NOTICE TO ALL CONTRACTORS:

Official Notice 27-2013: Rehabilitation of the St. Paul Avenue Lift Bridge over the Milwaukee River

This is Addendum No. 2, which provides for the following:

SHEET S4 OF S60 – TYPICAL SECTION FIXED SPAN

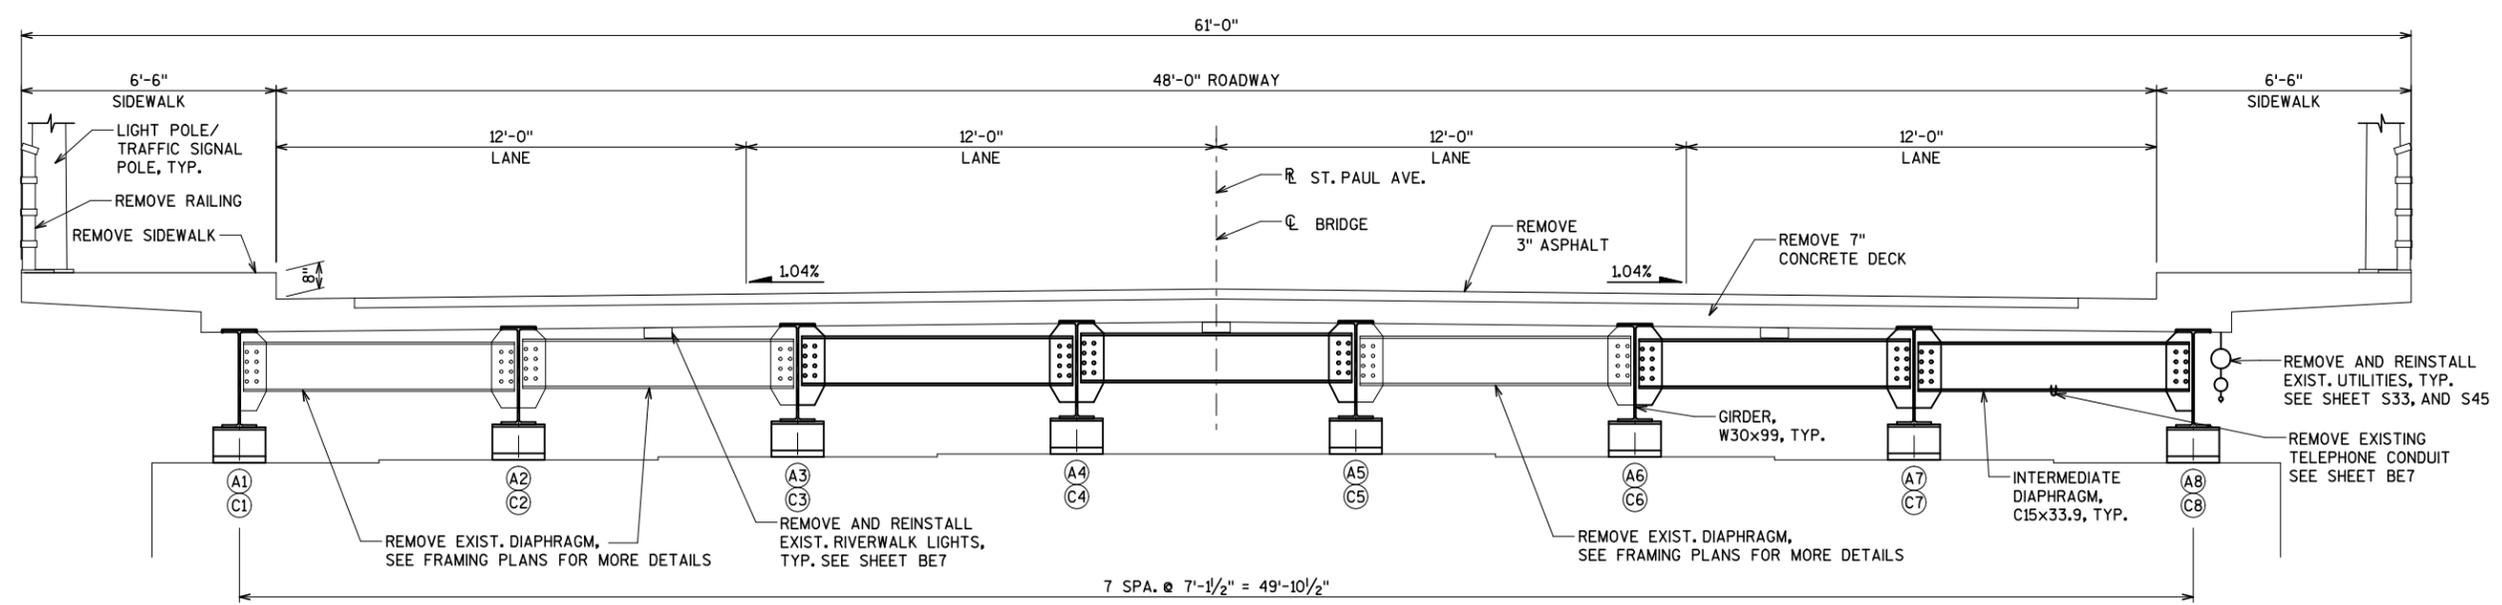
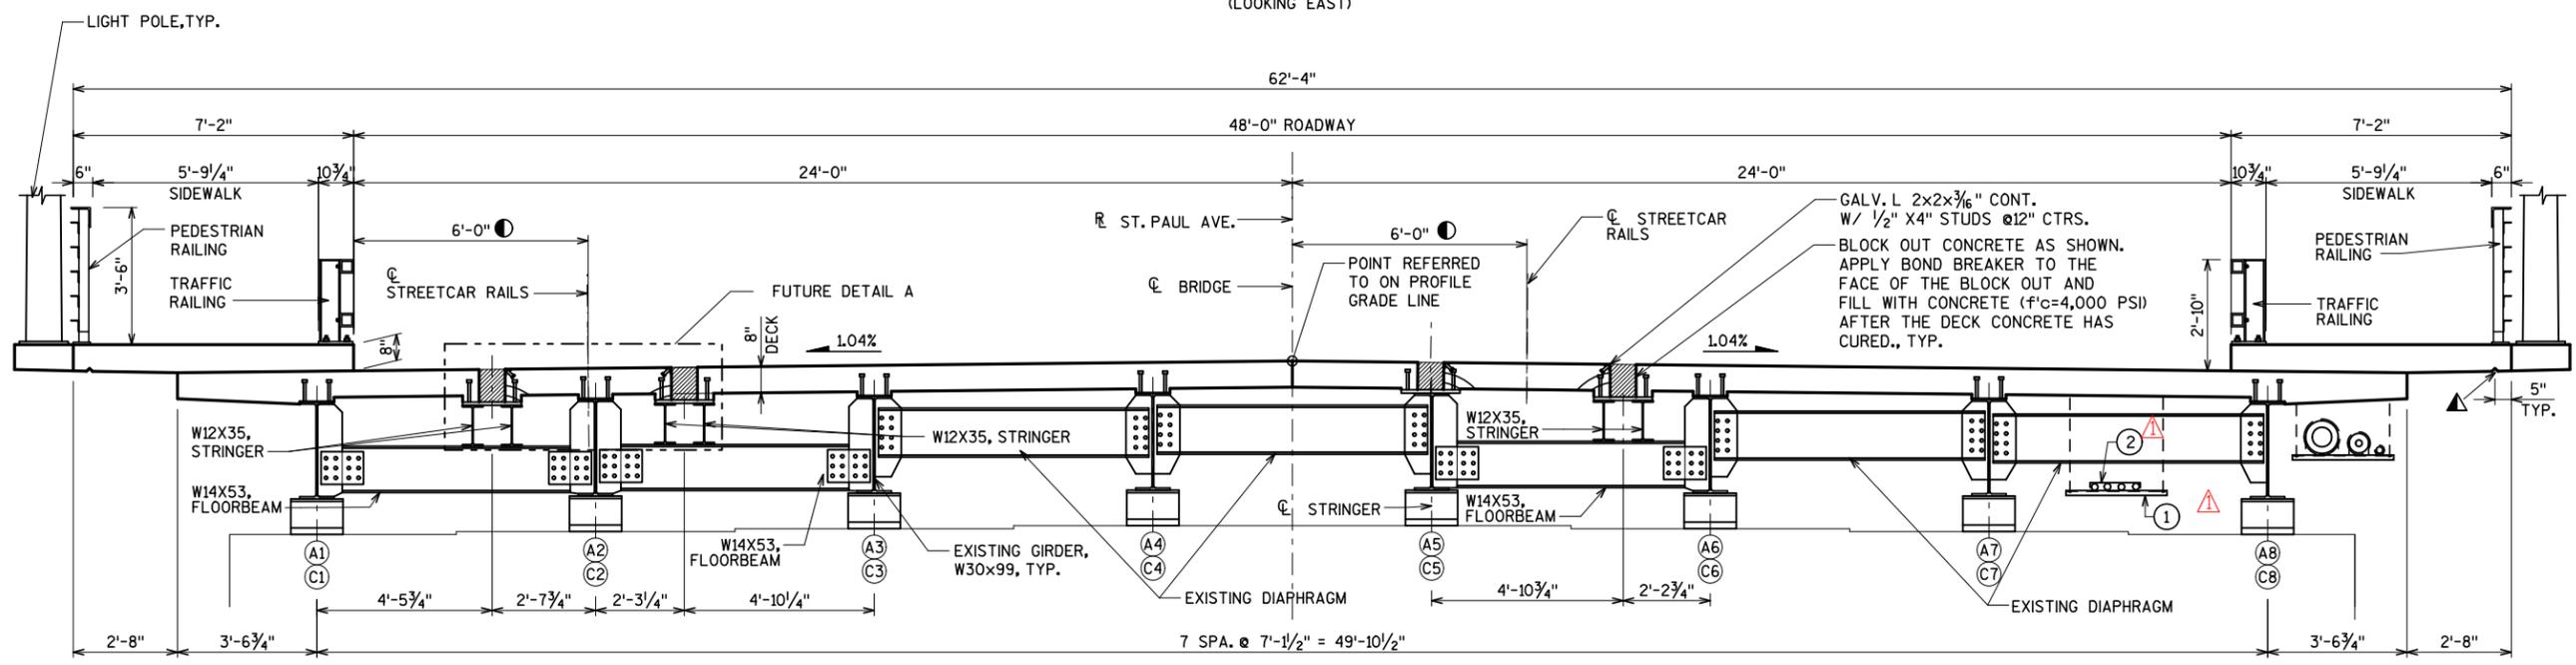
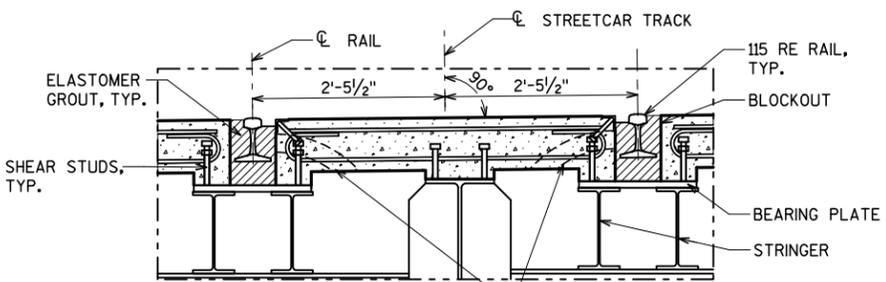
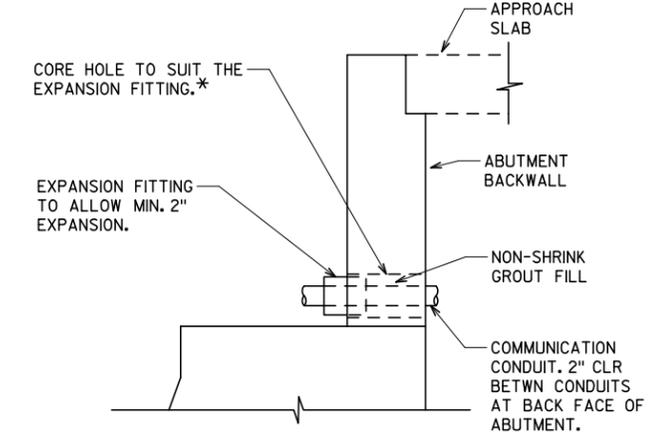
Updated “KEY NOTES,” and added “CONDUIT PENETRATION” Detail.

SHEET S10 OF S60 – EAST WINGWALLS RECONSTRUCTION

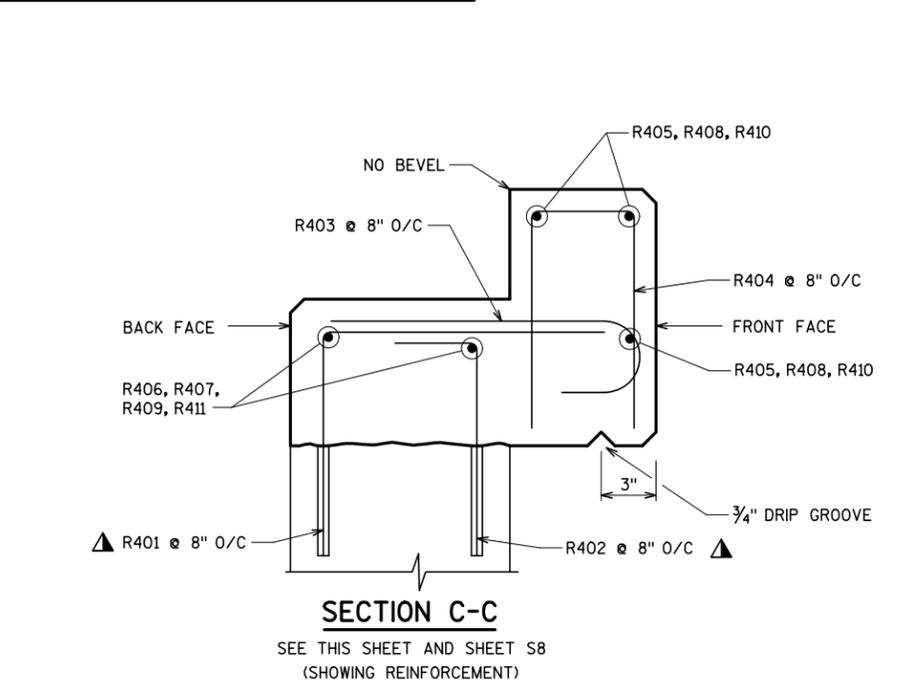
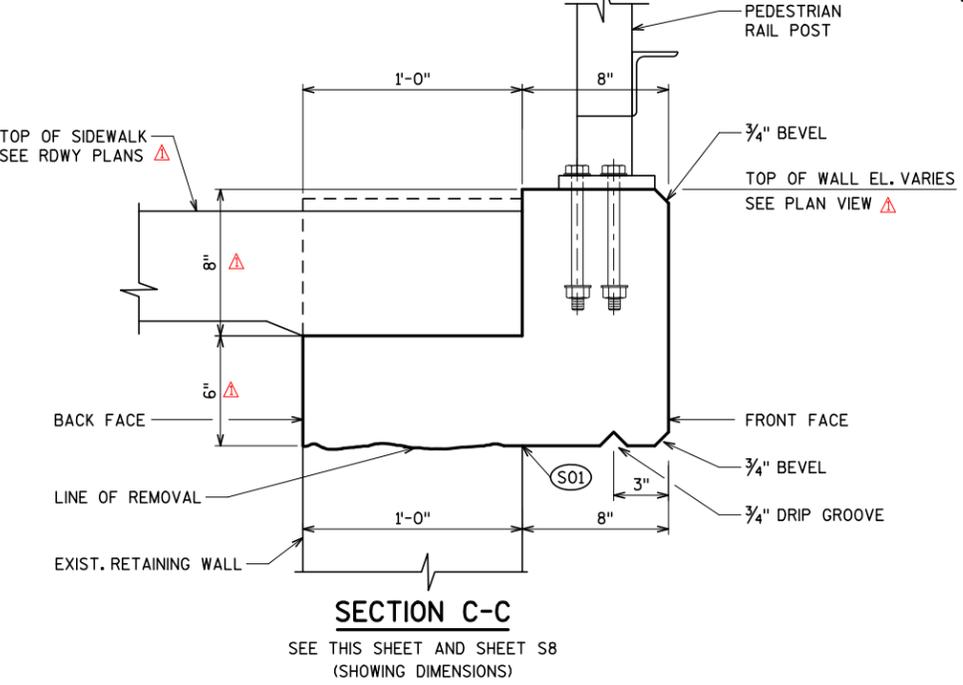
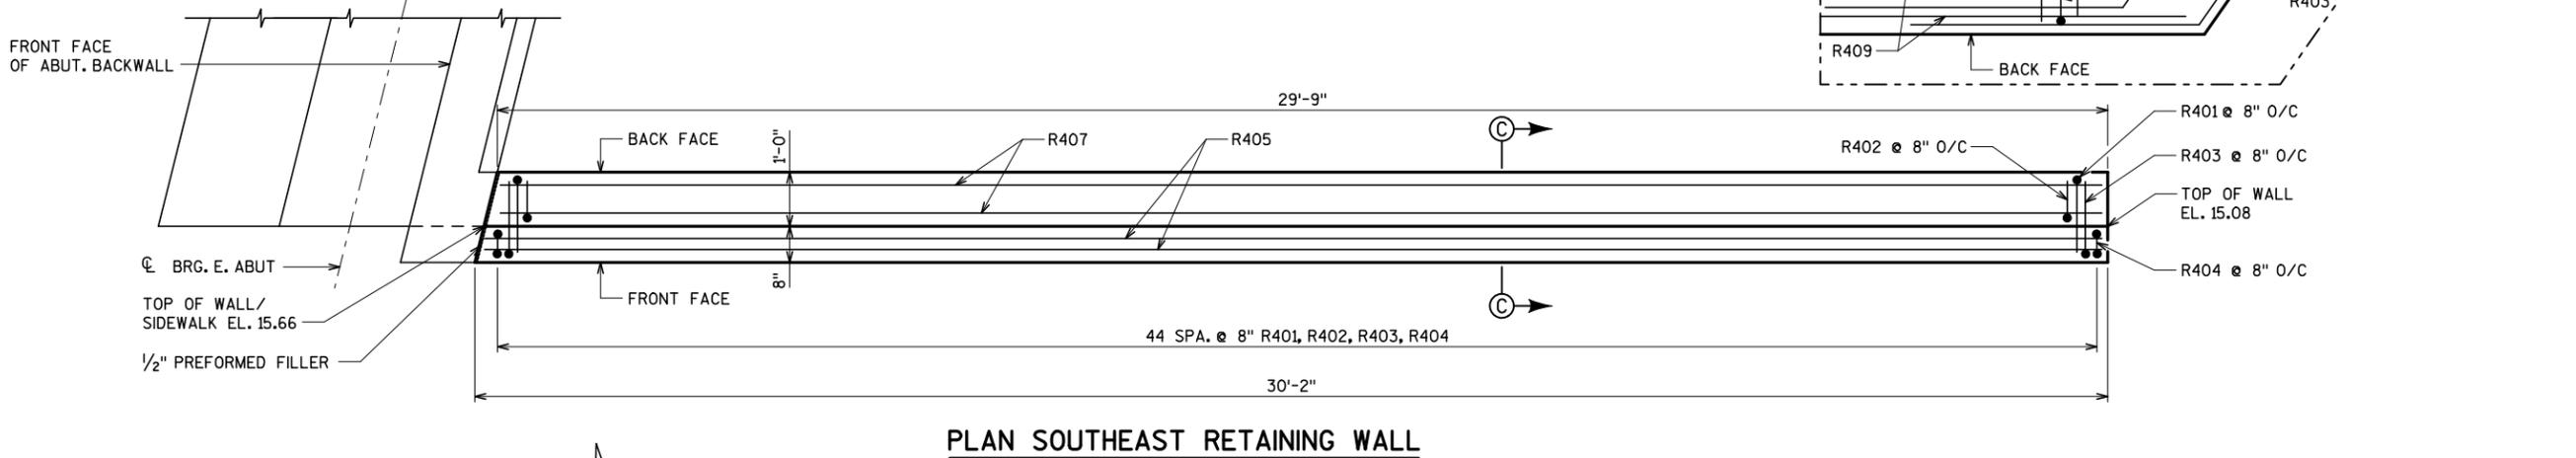
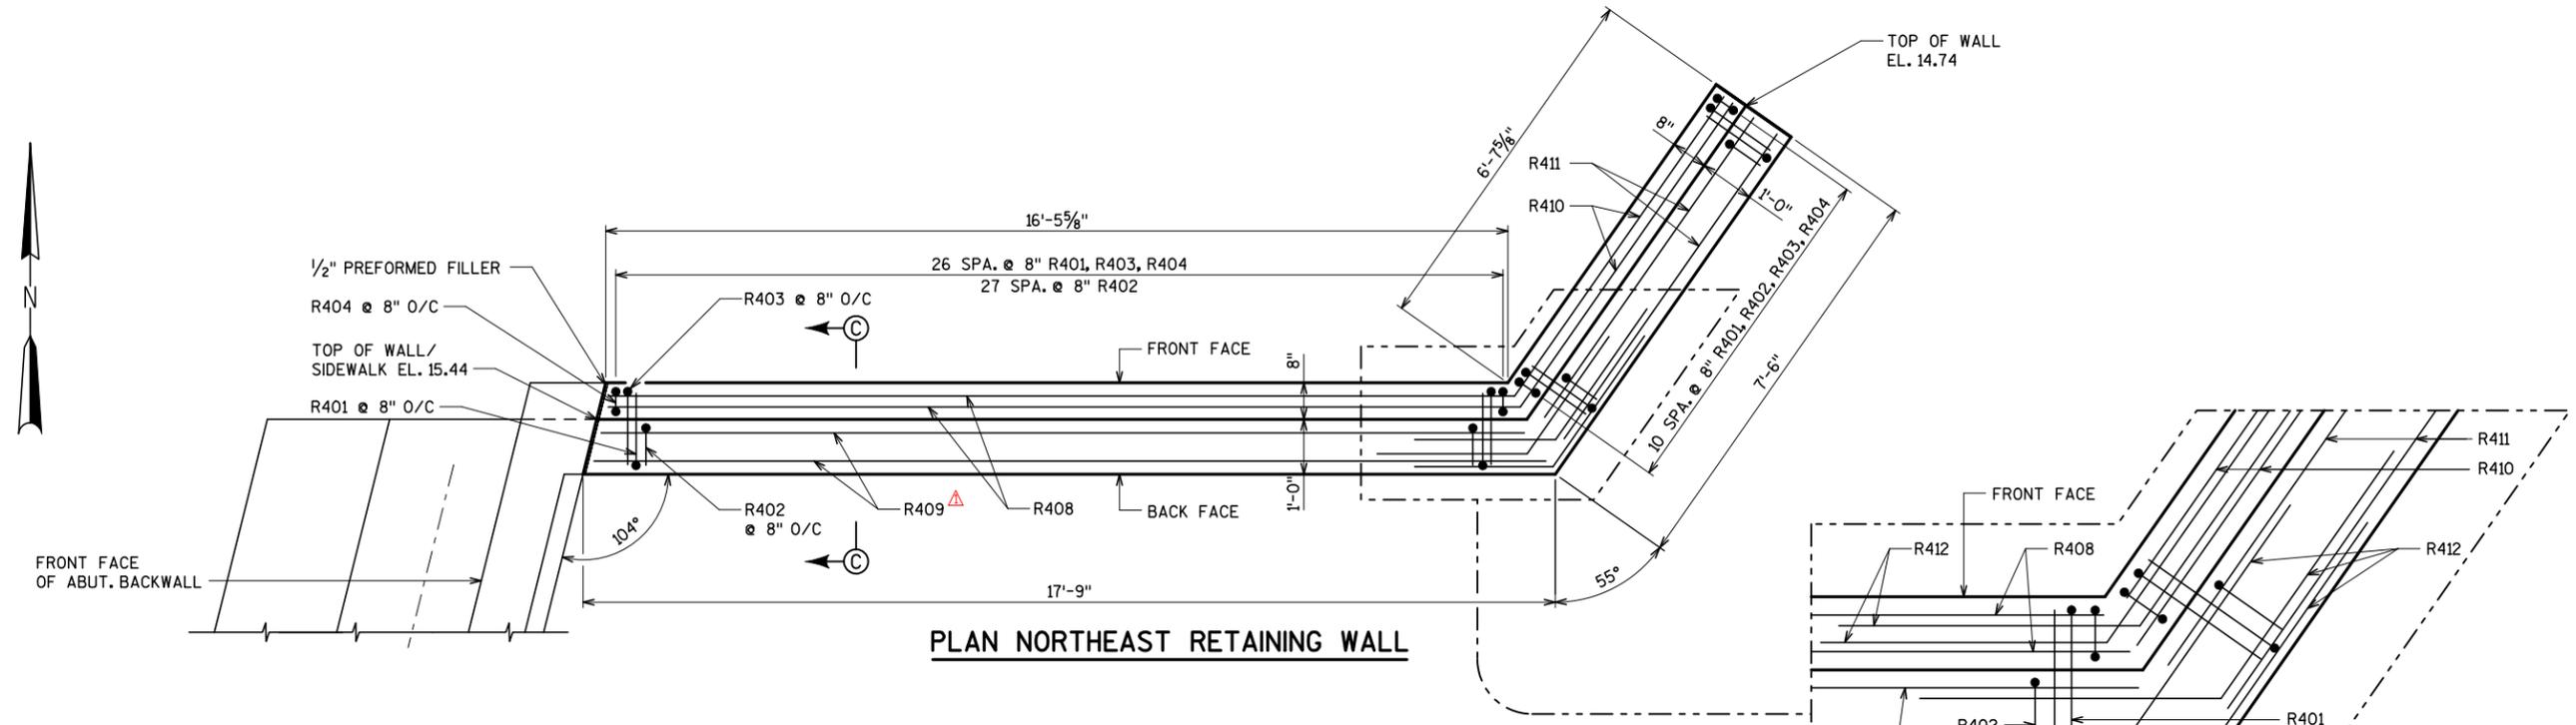
Dimensions and Notes have been updated on “SECTION C-C” and “PLAN NORTHEAST RETAINING WALL”

SHEET S16 OF S60 – PIER 2 COLUMN RECONSTRUCTION

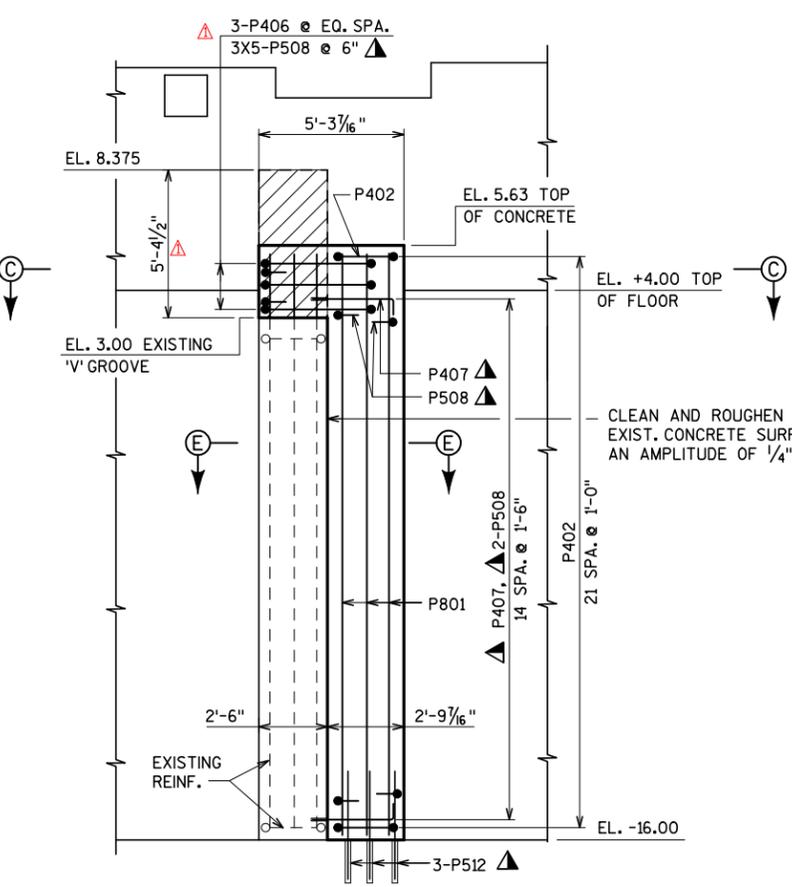
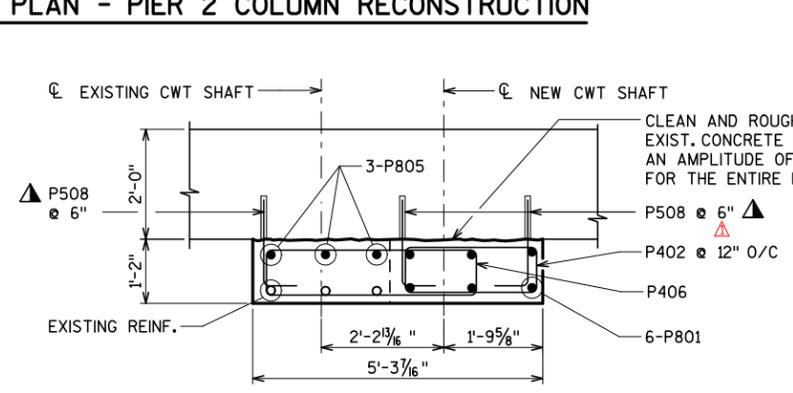
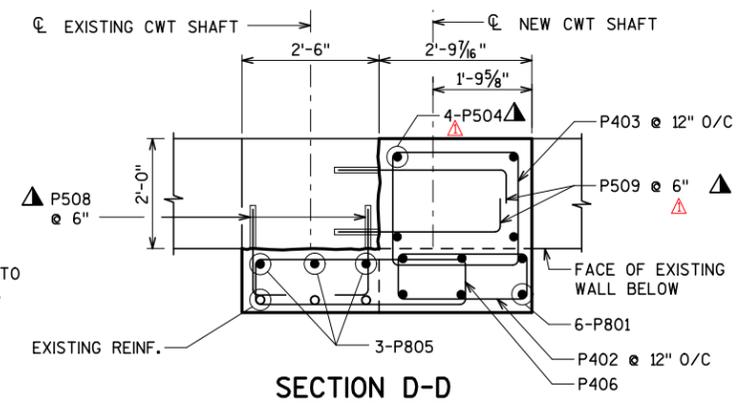
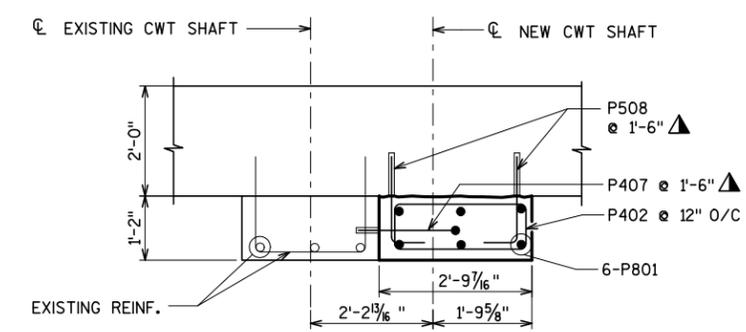
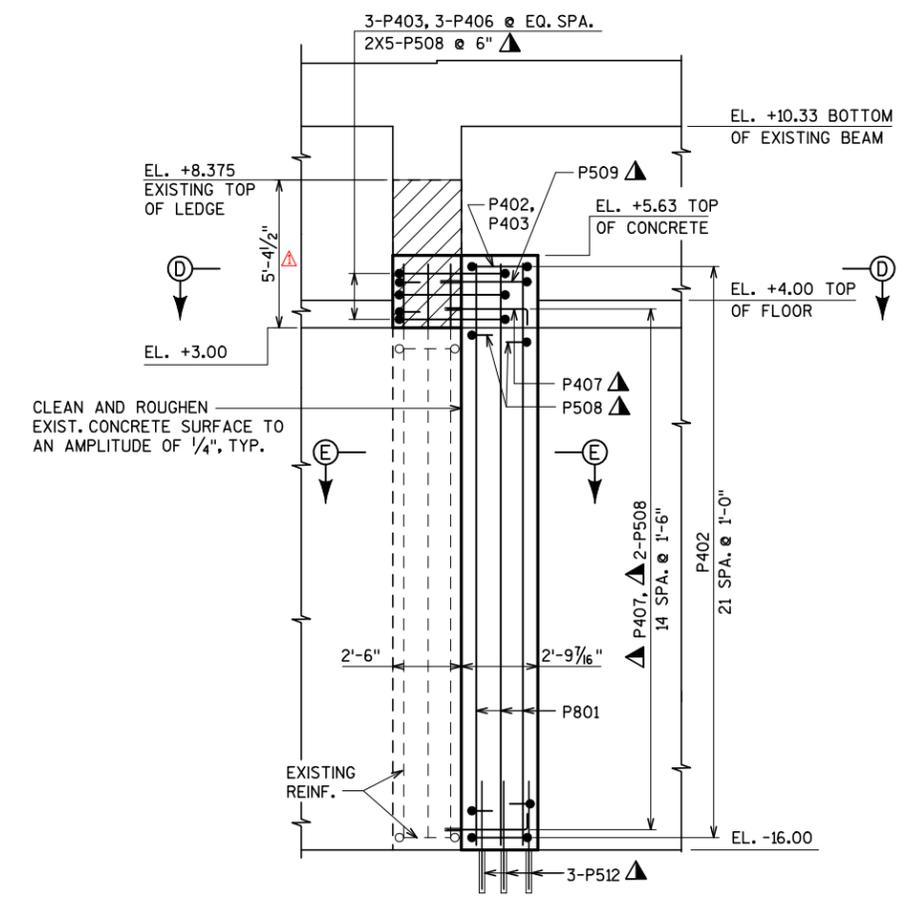
Updated Bar Spacing on “SECTION C-C”

Updated Bar Spacing and Bar Mark on “SECTION D-D”

Updated Bar Mark and Dimensions on “VIEW A-A (EAST COLUMNS)”

Updated Dimensions on “VIEW B-B (WEST COLUMNS)”
